DART SERVICE BULLETIN SB08-1

**D412-702-021 / D412-702-023 / D412-702-025 / D412-702-027 / D412-702-029 / D412-702-031 / D412-702-033
/ D214-702-035 Shoulder Harness Kits (4 Point Metal to Metal)**

B	REVISED NOTE 1 TO CHANGE "SSP" CODE CRITERIA. DELETED NOTES 2 AND 3. DELETED PHOTO 2.			MP	08.06.04
A	NEW ISSUE			HS	08.05.28
REV.	DESCRIPTION			BY	DATE
DESIGN	SW	DART AEROSPACE LTD HAWKESBURY, ONTARIO, CANADA			
DRAWN	HS				REV. B
CHECKED	DS	DRAWING NO. SB08-1			SHEET 1 OF 3
MFG. APPR.	N/A				TITLE
APPROVED	<i>[Signature]</i>	SERVICE BULLETIN			NTS
DE APPR.	<i>[Signature]</i>	COPYRIGHT © 2008 BY DART AEROSPACE LTD			
DATE	08.06.04	THIS DOCUMENT IS PRIVATE AND CONFIDENTIAL AND IS SUPPLIED ON THE EXPRESS CONDITION THAT IT IS NOT TO BE USED FOR ANY PURPOSE OR COPIED OR COMMUNICATED TO ANY OTHER PERSON WITHOUT WRITTEN PERMISSION FROM DART AEROSPACE LTD.

**FIGURE 25.9A, D3446-041
SHOULDER HARNESS
(INCLUDED IN D412-702-021/
-023/-027/-029 KITS)**

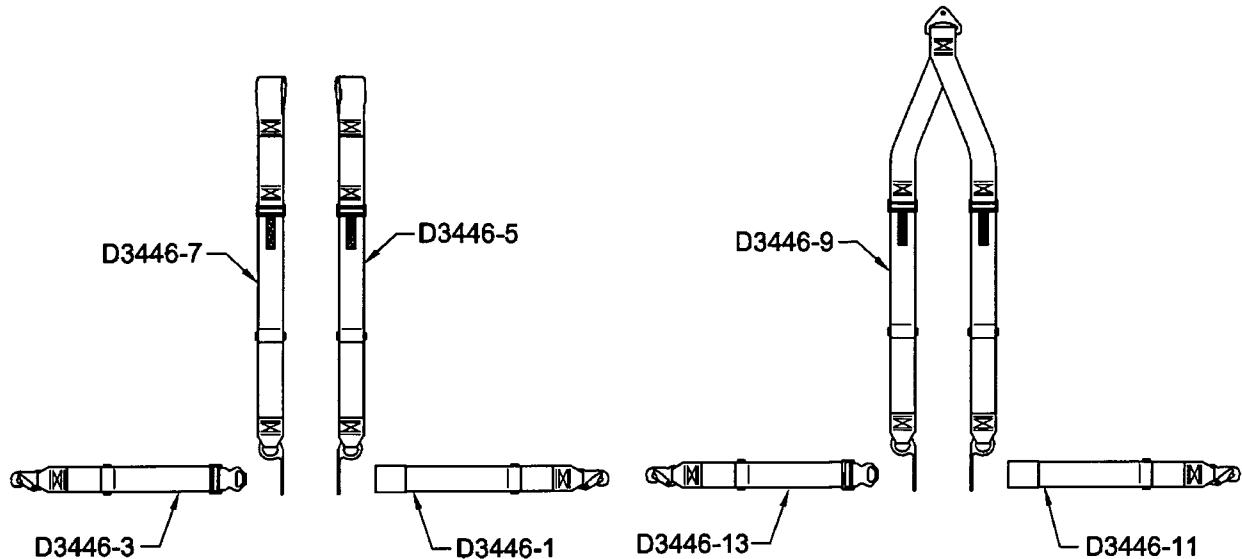
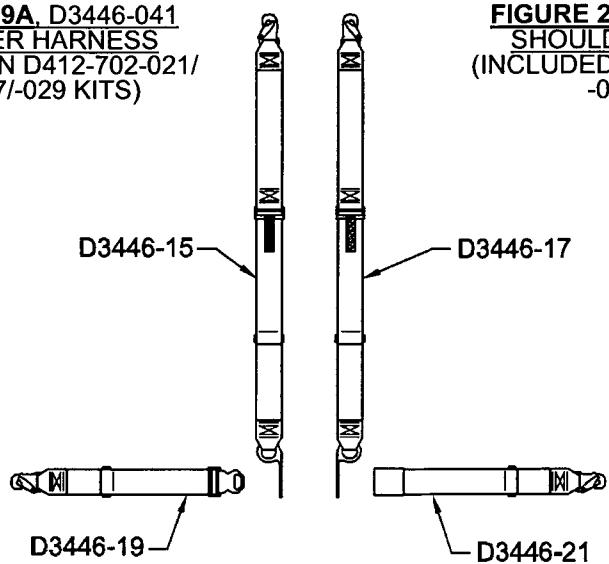
- 2) Deleted
- 3) Deleted
- 4) Replacement D3446-1/-11/-21 and D3496-7 buckle assemblies (refer to Figure 25.9 of ICA-D412-702 Rev. 3) are available from Dart Aerospace Ltd AT NO CHARGE. Contact Sian Willems @ 613-632-5200 or by email @ swillems@dartaero.com referencing this Service Bulletin.

- 6) In order to minimize the impact of this situation on our customers, Dart Aerospace Ltd. will be shipping replacement buckle assemblies. Please note that buckle assemblies labeled "D3446-041", "D3446-043", "D3446-045" and "D3496-041" are all functionally identical and interchangeable. For shipments received as a result of service bulletin SB08-1, it is acceptable to install buckle assemblies whose identification tag does not match the rest of the existing shoulder harness kit in the aircraft.
